ADDENDUM #1**1.1 PROJECT INFORMATION**

- A. Project Number: 2026-11230
- B. Project Title: BEB On-Route Charging Infrastructure
- C. Project Location: STA's Valley Transit Center at 10501 E 4th Ave, Spokane Valley, WA & Liberty Lake Park & Ride at 22501 E Mission Ave, Liberty Lake, WA
- D. Agency: Spokane Transit Authority

STA Route 9 BEB Charging Addendum #1 Narrative

1	06/15/26	ADDENDUM #1
REV	DATE	DESCRIPTION
PROJ. NO.	2026-11230	
DRAWN	CBP	
CHECKED	CJB	
DATE	05/27/2026	
© COFFMAN ENGINEERS INC.		
SHEET TITLE:		
CONSTRUCTION STAGING AND PHASING PLAN		
SHEET NO:		
G-100

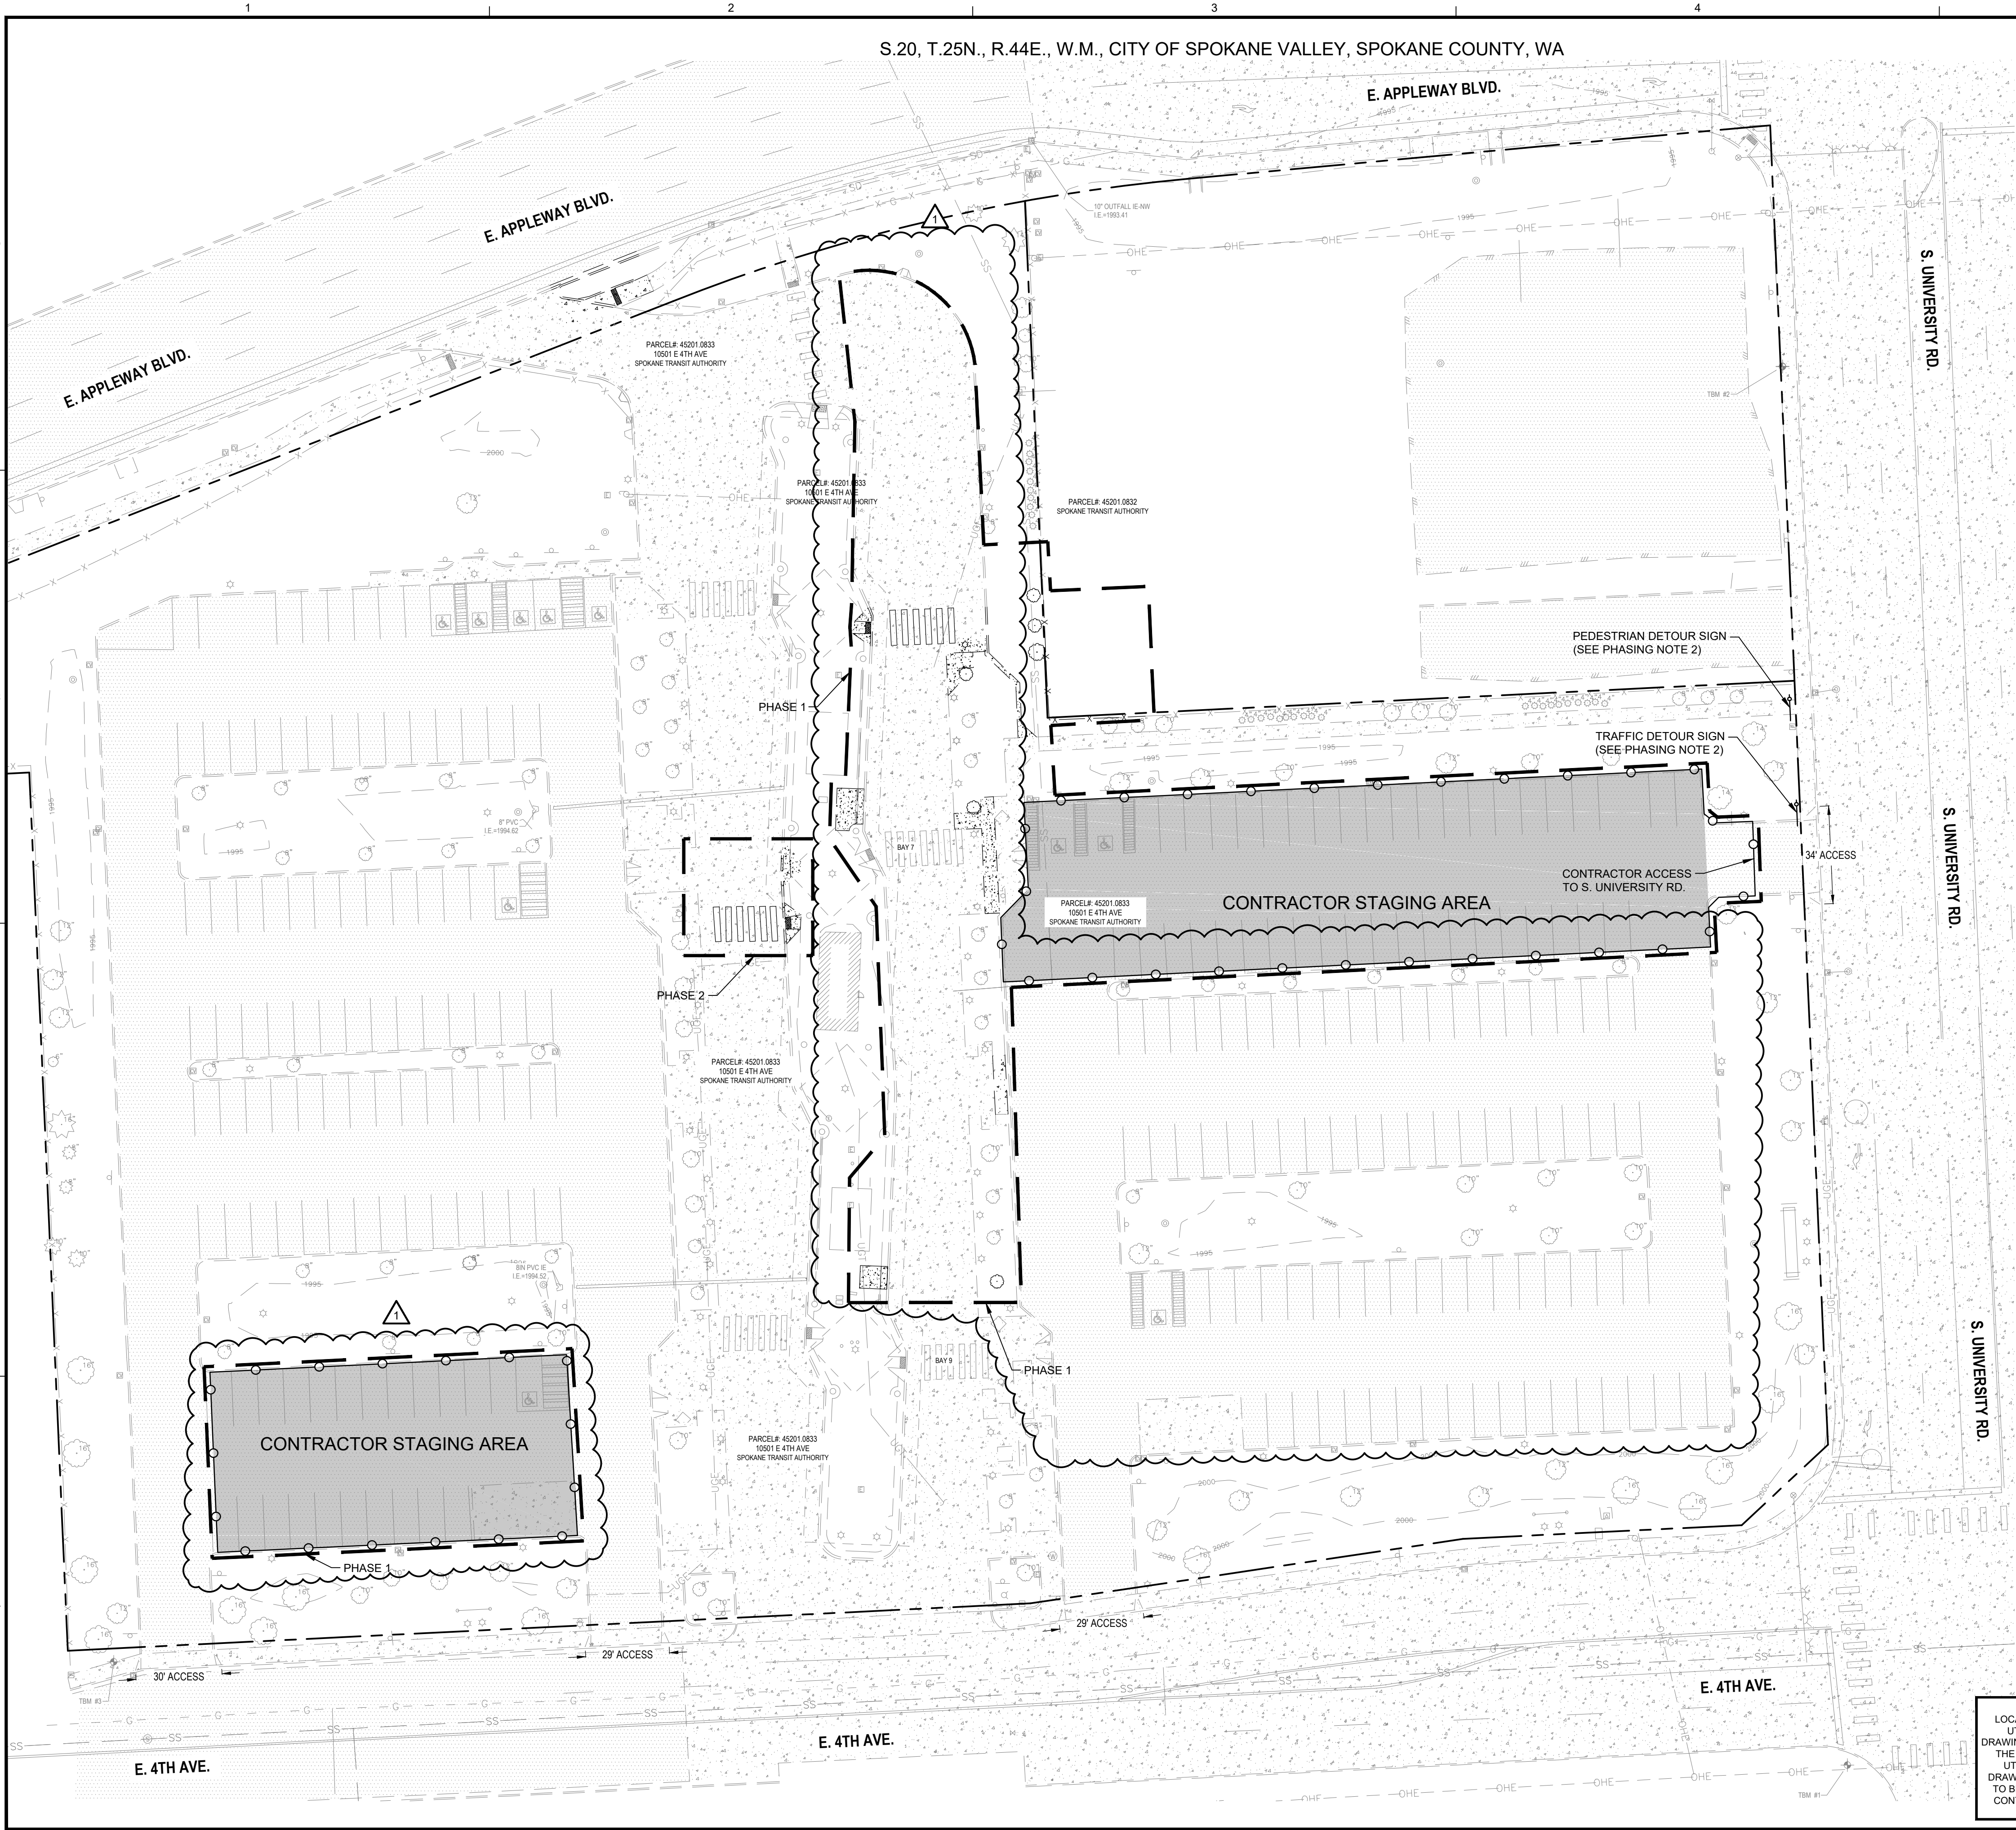
A. SHEET G-100 – CONSTRUCTION STAGING AND PHASING PLAN

1. Revised: Contractor staging areas.

C-302

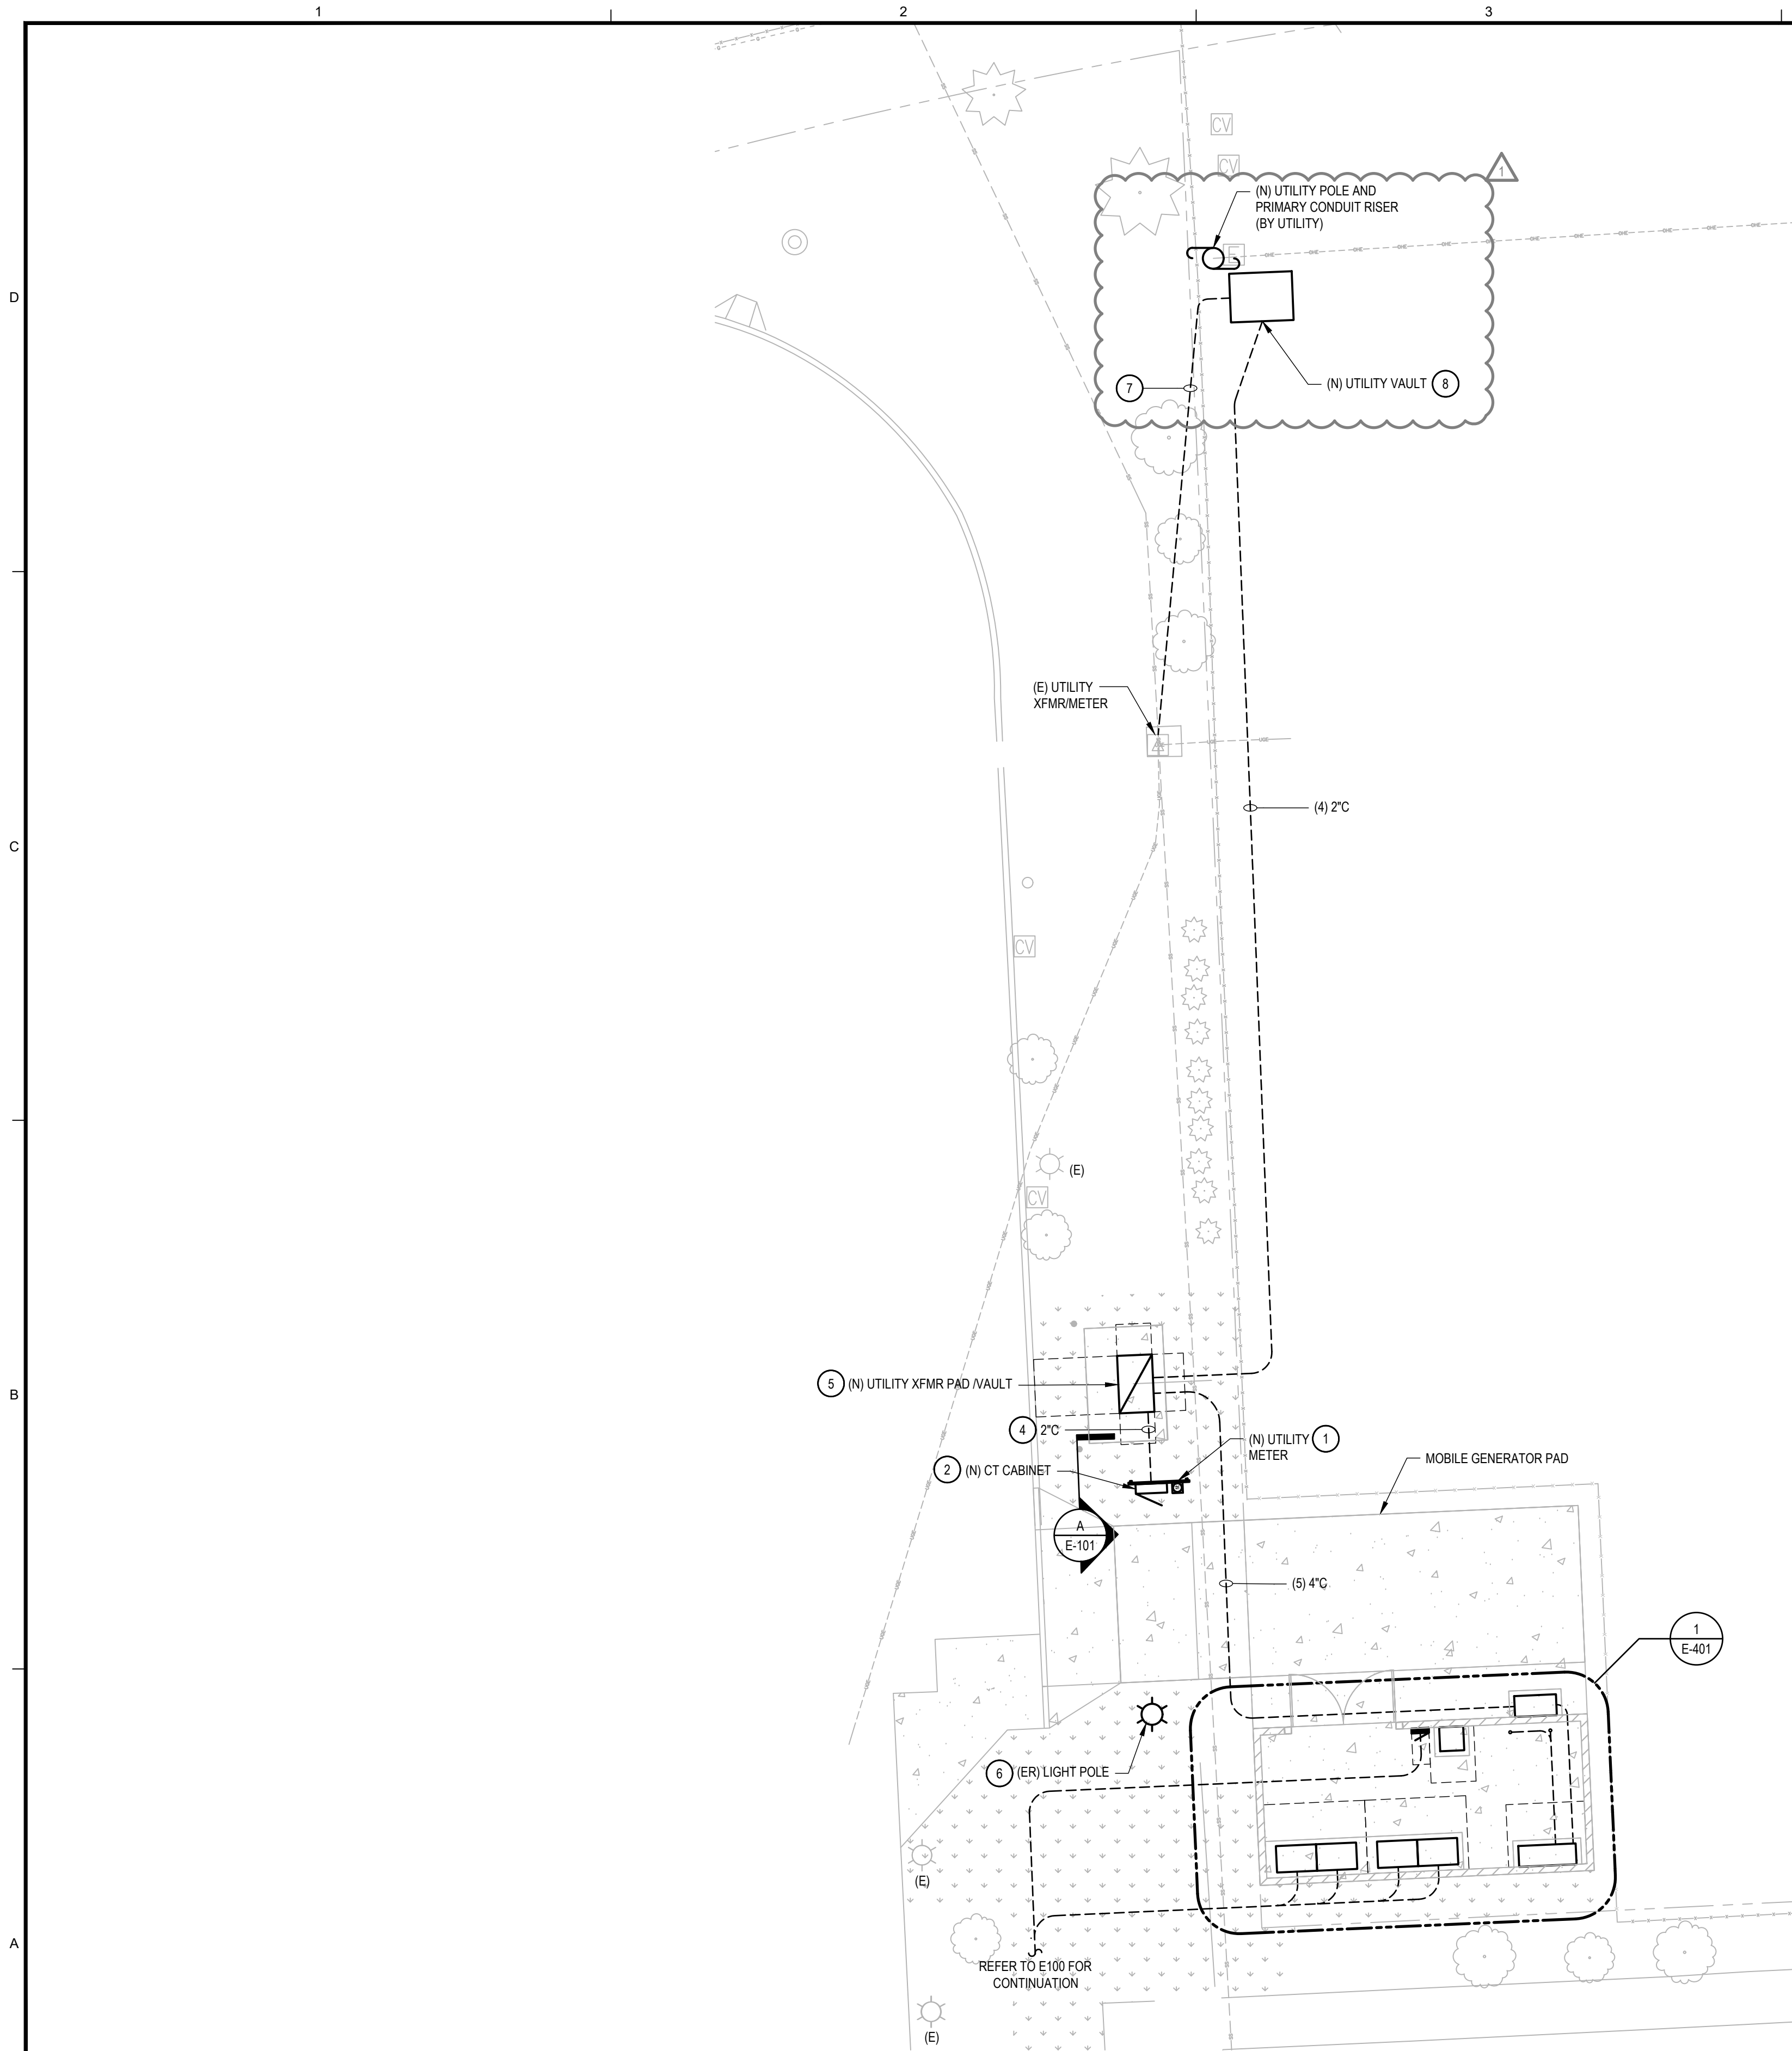
C. SHEET C-302 – SITE PLAN

1. Revised: Key Note E to note conduit sleeves.

- (E) CONCRETE PAD FOR ELECTRICAL EQUIPMENT. SEE DETAIL 5, SHEET C-501 AND STRUCTURAL PLANS. INSTALL SLEEVES FOR ELECTRICAL CONDUITS, SEE ELECTRICAL PLANS.
